SUBJECT: Lake Orion Dam, Dam ID No. 259, Oakland County

**DAM SAFETY INSPECTION REPORT
LAKE ORION DAM – DAM ID NO. 259
PAINT CREEK
OAKLAND COUNTY – SECTION 2, T04N, R10E**

INSPECTION DATE: October 24, 2024

Photo #15: Auxiliary Spillway Outlet Conduit. Note spalling and deterioration of retaining wall on right side.

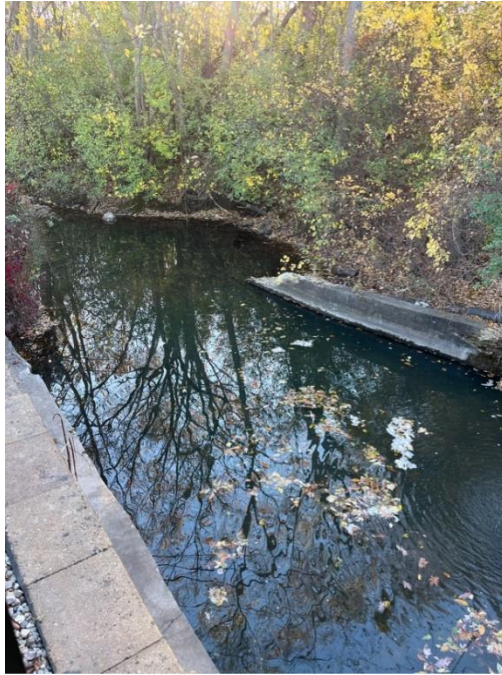
Auxiliary Spillway		
Issues Present	<i>Deteriorating Material</i>	
Deteriorating Material		
Describe Issue	<i>Significant spalling and deterioration were observed at the concrete retaining wall at the outlet, and the concrete headwall and upstream columns of the auxiliary spillway.</i>	
Component	<i>Outlet Conduit</i>	<i>Headwall</i>
Photo(s)	15	21 , 22 , 23 , 24
Action Required	<i>Monitor, Maintenance</i>

Issue: Deteriorating Material, Action: Monitor, Maintenance

Describe Action Required	<i>Inspect locations of concrete deterioration, a minimum of twice per year, to ensure the deterioration is not increasing in size. Consider concrete repairs in the next five (5) years to prevent concerns.</i>
--------------------------	---

Photo #30: Embankment Upstream Slope. Left slope shown.
Issue: Trees and Brush, Action: Maintenance

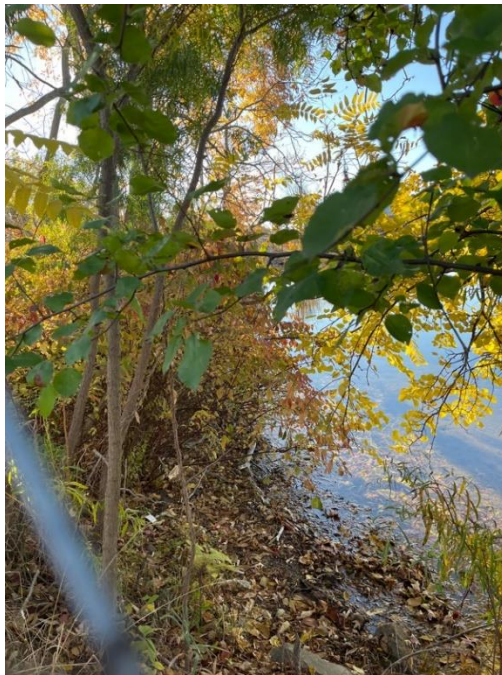
Embankment	
Upstream Slope	
Issues Present	<i>Trees and Brush</i>
Trees and Brush	
Describe Issue	<i>Trees, brush, and woody vegetation were observed on the upstream embankment slope.</i>
Photo(s)	28 , 29 , 30
Action Required	<i>Maintenance</i>
Describe Action Required	<i>Continue efforts to remove all trees and brush from the earthen embankments. Trees should be removed to 10 feet beyond the downstream toe of slope. Once cleared, embankments should be mowed or treated with herbicide a minimum of two (2) times per year to prevent further establishment of woody vegetation and to facilitate visual inspection.</i>

2. **Trees and Brush (Action: Maintenance):** Continue efforts to remove all trees and brush from the earthen embankment. Flush cut and/or grind stumps and remove clearing debris from the embankment. The stumps should be cut a maximum of one (1) foot above ground. Establish appropriate vegetation if stump is to be ground. We do not recommend uprooting trees for removal. Tree roots can lead to piping failure by cultivating flow paths in the embankment especially when the tree dies. Trees can also cause extensive damage and/or failure when they are uprooted from a storm. Complete action by December 31, 2026.
